# febi 39304

## Water pump with gasket

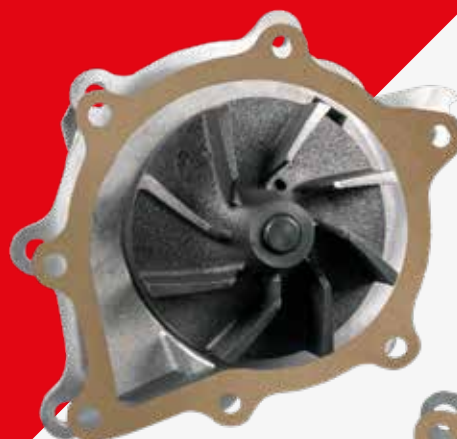
*Improved febi water pump*

*Original design*

The original water pump impeller is made from plastic, which can become detached from the impeller shaft. Therefore, the water pump is turning with no effect and no coolant will flow around the cooling circuit of the engine.

Remove the auxiliary belt and timing belt. Replace the defective water pump with febi water pump 39304 (Fig.1), which has an improved water pump design with a metal impeller. This eliminates the potential failure caused by the water pump fitted with a plastic impeller. When replacing the faulty water pump, febi recommends that the timing belt kit and auxiliary drive belt is also replaced at the same time to ensure the reliability of the engine.
